Title: 33-35 Jamestown Road and 211 Arlington Road - Transport Assessment

Addendum

PROPOSED CYCLE STORE PART PLAN

A1. DIMENSIONS CYCLE STORES PLAN

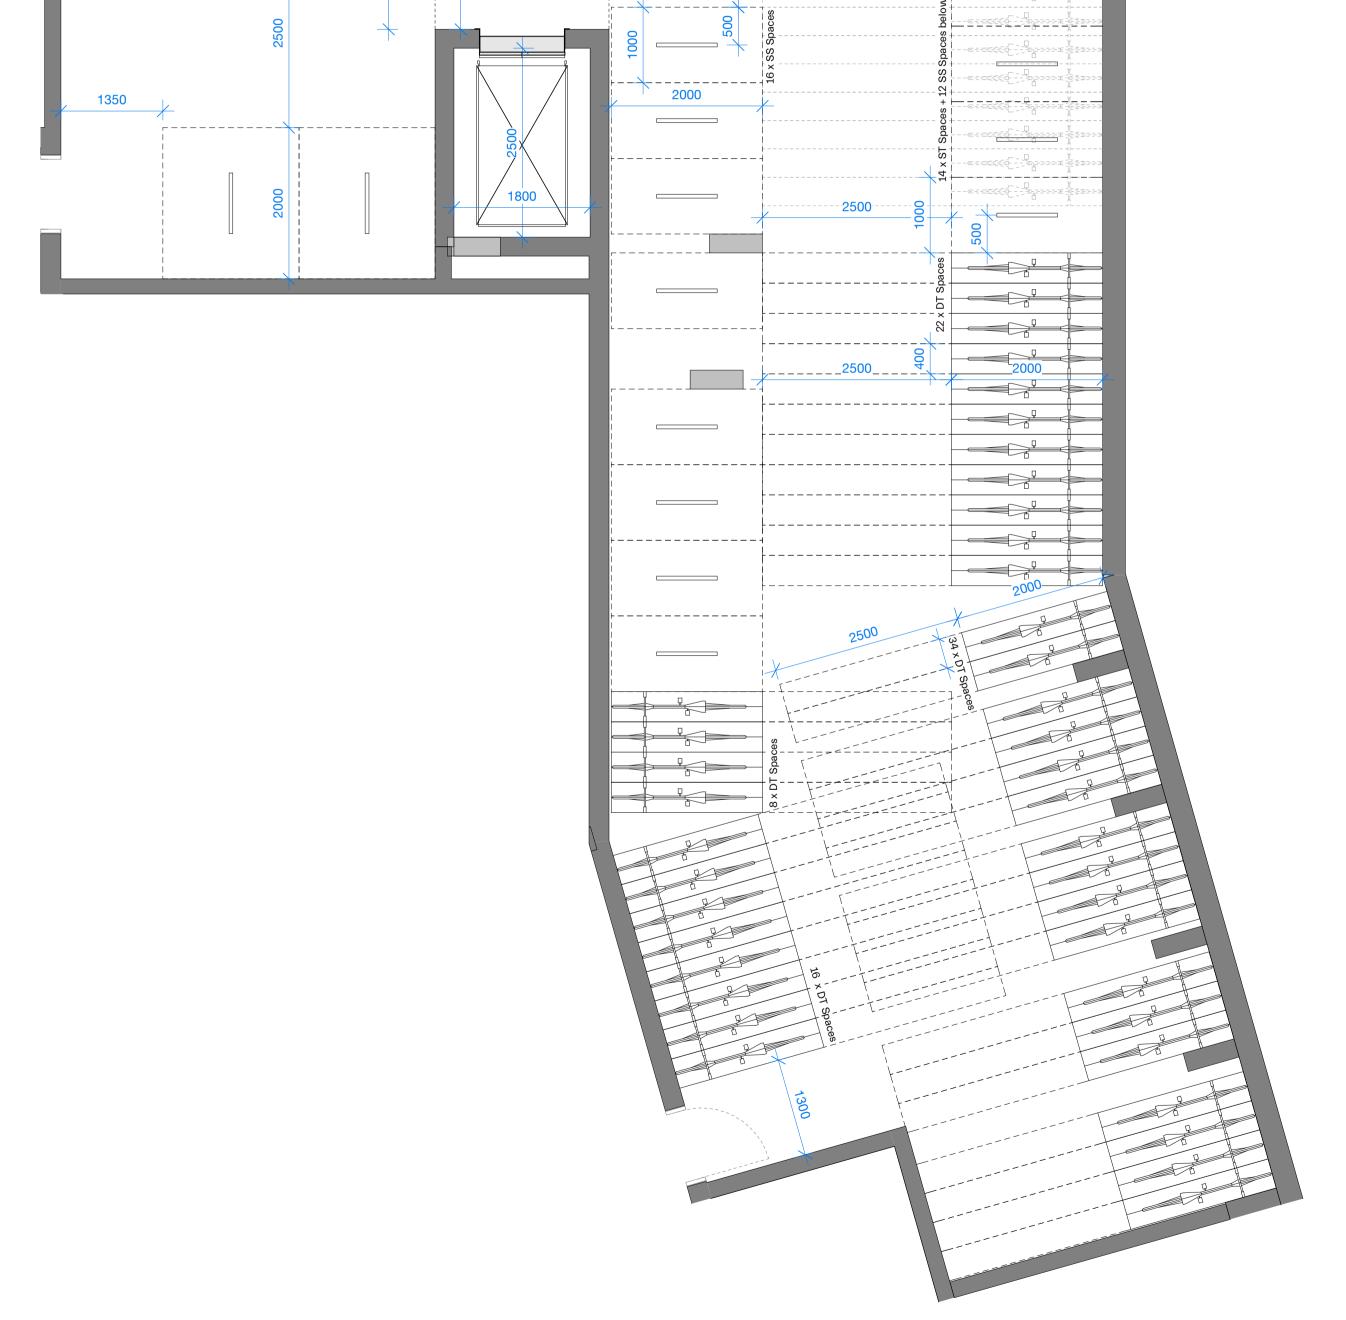
- 12. For cycle parking, the reduction of 9 PBSA beds results in a new requirement of 134 long stay cycle parking spaces, rather than the previous requirement of 141. The dedicated cycle store for this use has therefore been updated to reflect this number, and it retains the split of different types of cycle spaces, with 8 (6%) larger stands for adapted bikes etc and 28 (21%) as CaMden stands. The remaining 100 spaces are in the form of two-tier racks. The cycle store is designed in accordance with the London Cycling Design Standards (LCDS), featuring the correct spacing between stands and ceiling heights. A dimension plan is included at **Appendix A1**.

- 14. Lastly, the residential units remain at 27 dwellings, however, given the slight change in mix (introduction of 1-bedroom units) the long-stay cycle parking requirement is now 52 spaces rather than 54. However, the proposals retain the 54 spaces (again with the required split of cycle parking types as shown in the appended plan) and therefore provide cycle parking in excess of the standards.

Long Stay Spaces 136 Total 8 Accessible (AC) 5%

28 Sheffield Stands (SS) 20% 100 Double-Tier (DT)
